**TOWN OF GLASTONBURY  
 BID NO. GL-2026-22  
 50 NYE ROAD PARKING LOT IMPROVEMENTS LANDSCAPING, FENCING AND TURF  
 ESTABLISHMENT INSTALLATION**

**ADDENDUM NO. 1  
 MARCH 27, 2026**

TIMBER POST INSTALLATION DETAIL  
SCALE : N.T.S.

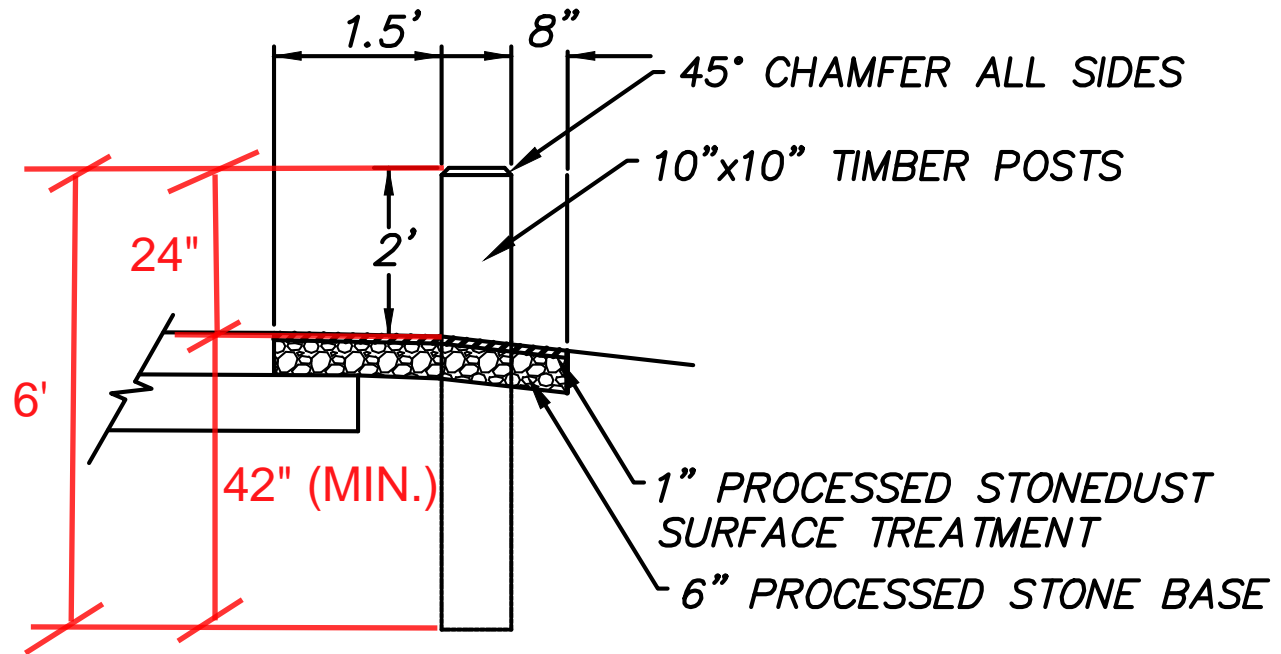
Q1-1:	Please identify the anticipated start date for this contract?
A1-1:	As outlined in the specifications, the anticipated start date will need to be coordinated with Town staff with a mutually agreed upon start date.
Q2-1:	Section 1.10 Environmental Compliance- Please identify who will supply, install, and maintain Exclusionary fencing for the Box Turtle and Green Snake for this contract?
A2-1:	The Town of Glastonbury personnel will be furnishing and maintaining the exclusionary fencing. Contractors should be aware and conform to these requirements while performing the contracted work.
Q3-1:	Item #0906006A- 10" x 10" Timber Post- Please identify the length of the supplied posts?
A3-1:	Attached special provision and detail for this item has been revised to reflect a 10" x 10" x 6' Timber Post.
Q4-1:	Item #0906006A- 10" x 10" Timber Post- Please identify the depth the post is to be set in the ground?

A4-1:	Timber post shall be set below grade a minimum of 42" per attached revised specification and detail.
Q4-1:	Item #0906006A- 10" x 10" Timber Post- The specification notes "Backfill for all dug holes shall be approved material". Please identify the "approved material" that is to be used for backfilling?
A4-1:	Approved backfill for the timber post can be native material free of large stones and organics.

In areas where no existing underground utilities are present, post holes shall be drilled into firm undisturbed or thoroughly compacted soil **to a minimum depth of 42"**. The bottoms of dug holes shall be thoroughly rammed so that the posts have a stable foundation. Backfill for all dug holes shall be approved **native** material and is to be machine-tamped in 4-inch layers in such a way as not to shift the posts from the correct alignment.
